From: Neil Duffield
Sent: 25 February 2022 14:33
To: Hilary Saunders
Subject: NYM/2021/0881 NYM/2021/0876/FL Foulisyke House

PROJECT: **Foulsyke House
 Fylingdales YO22 4QL**

DRAWING: **Proposed
 Plans and Elevations
 Garden room and Link**

DRAWING No: **D12112-03** REV: **H**

South (front) Elevation
Scale 1:100

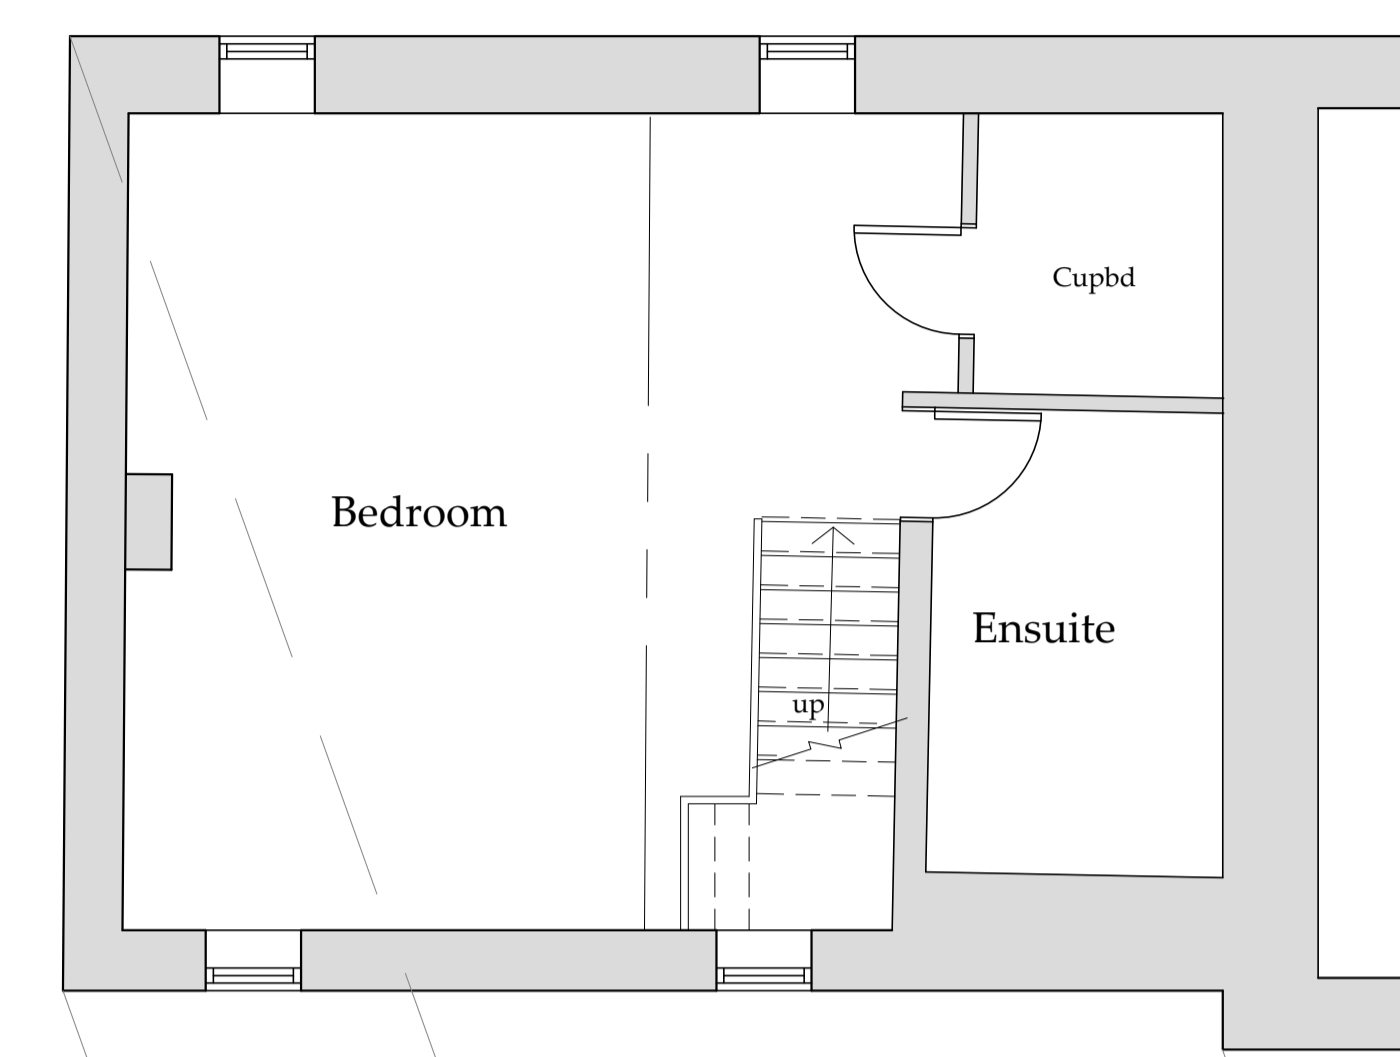
Visibility from the front elevation is minimal. The connecting element of the Link is set 700mm in reveal to ensure there is no impact on the front elevation of the House.

It is felt the creation of a new opening is preferable in the Piggery rather than using its existing door which would bring any Link works in front of the Front elevation.

Ground Floor Plan
Scale 1:50

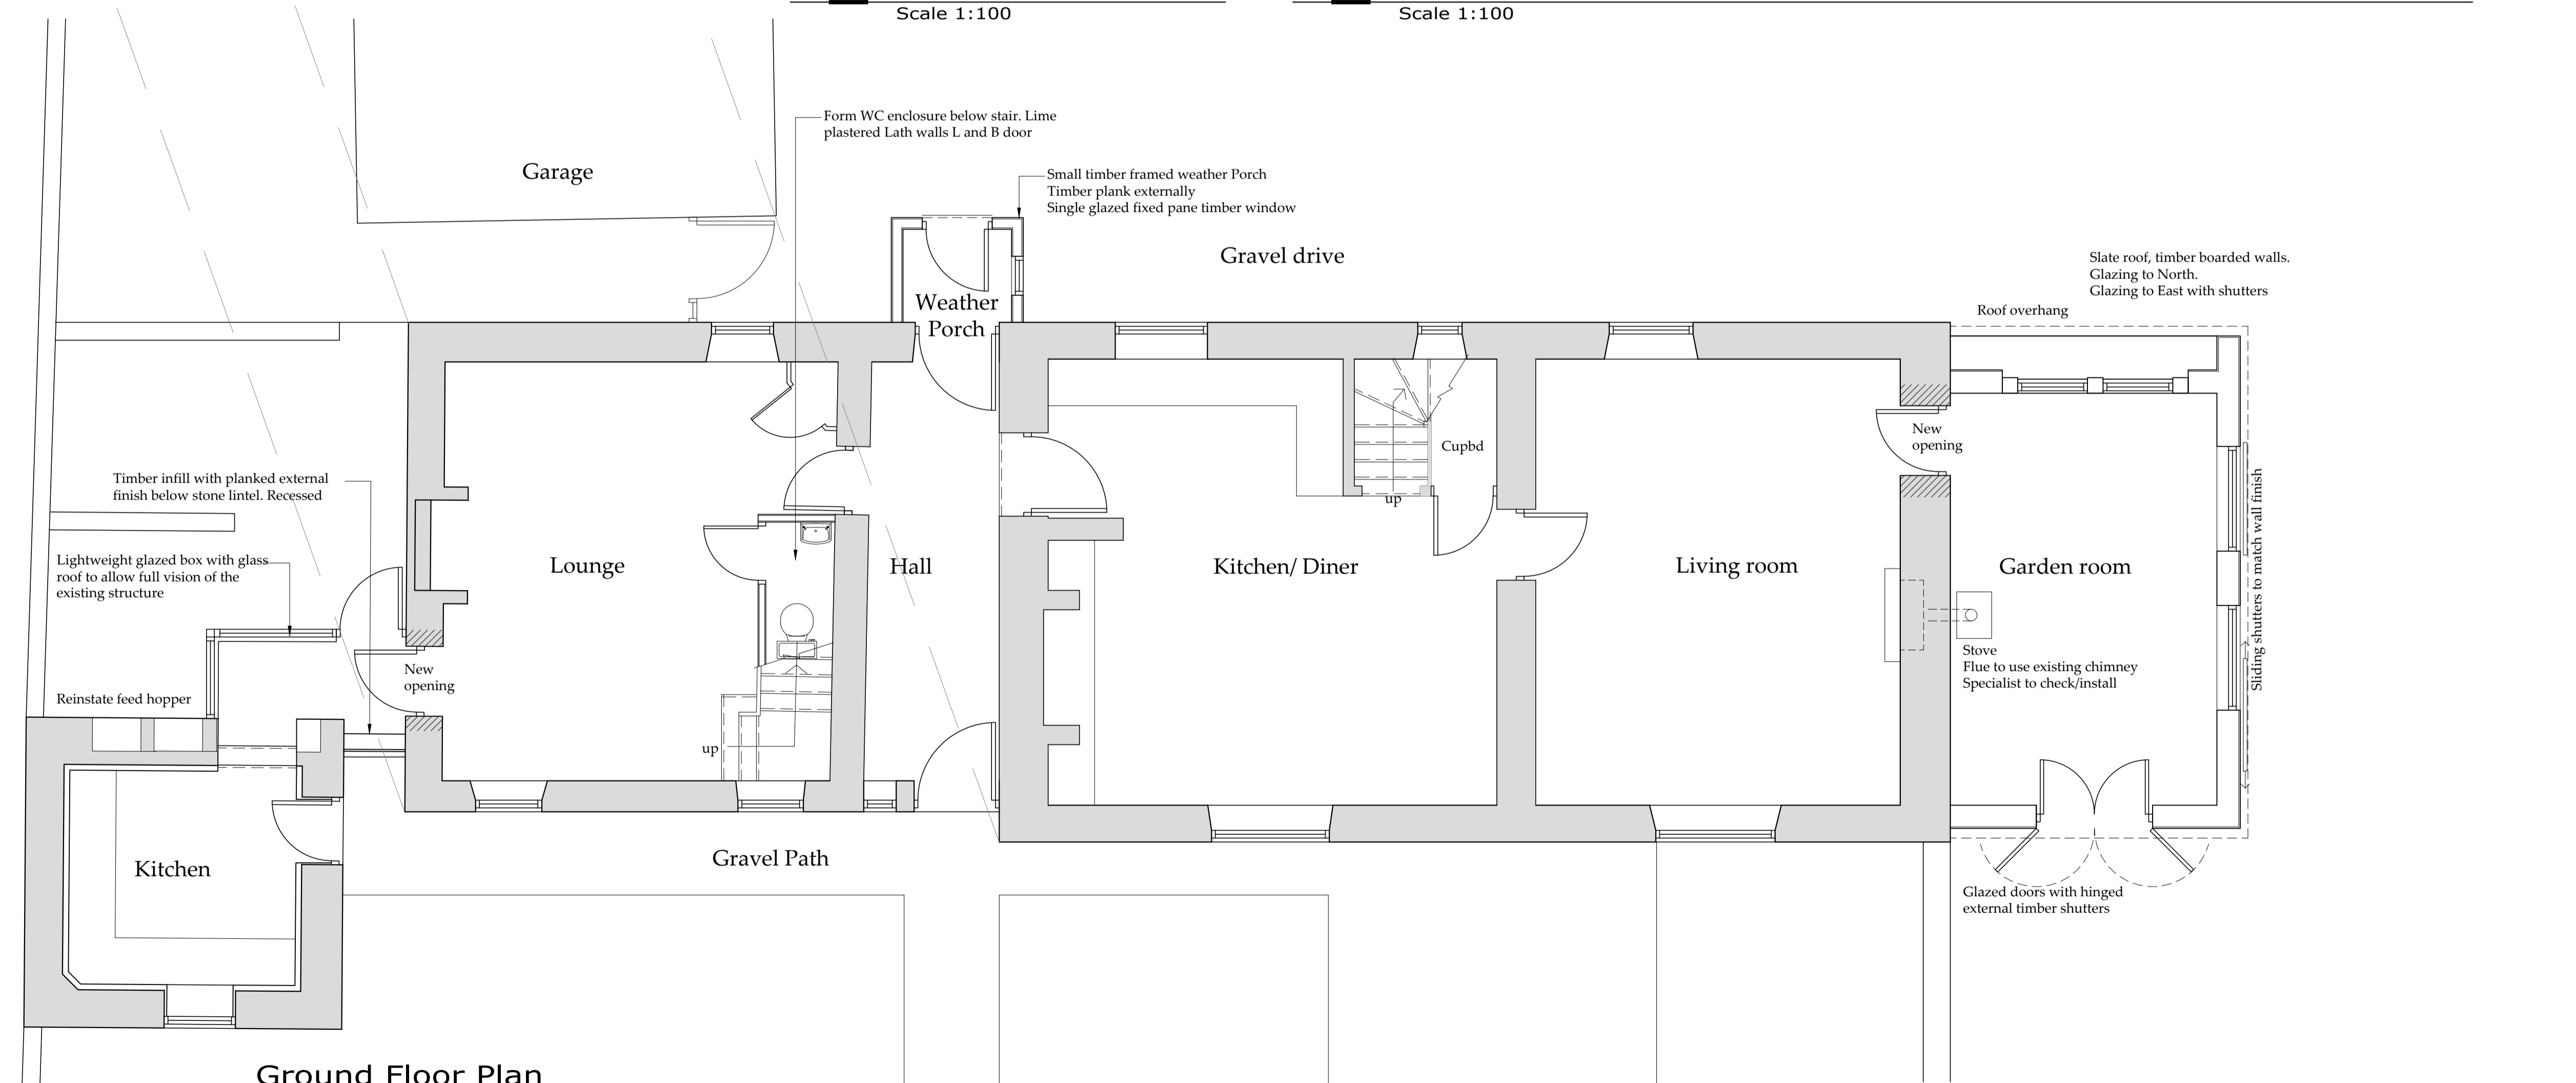
The Porch:

This has been reduced to a very simple Weather Porch, just large enough for the doors. As previously mentioned in the application the original door to the property on this rear elevation faces due North across open moorland.

Externally it is to be finished with dark timber planks.

It is kept low to avoid conflicting with the house eaves detail.

The WC has now been moved to below the Stair in the smaller 'Downhouse' Lounge

Garden Room:

This is now a simple Lean-to. A rebuilt version of the existing finished with a dark stained timber. Glazing to the North is recessed, to the East has sliding shutters, to the South has hinged shutters.

Kitchen and Link:

In terms of justifying the extra space needed for the Kitchen we appreciate that originally this would have been a self-sufficient Cottage however even for a single bedroom Unit the 26.5m² floor area is too small to accommodate the Stair up to the bedroom, the Living and Dining areas along with a Kitchen.

We have reduced the size to act as a very simple contemporary glass box the size of which purely matches its function to connect one room with the other.

It is accepted that a new opening is required in both the Piggery and Downhouse.
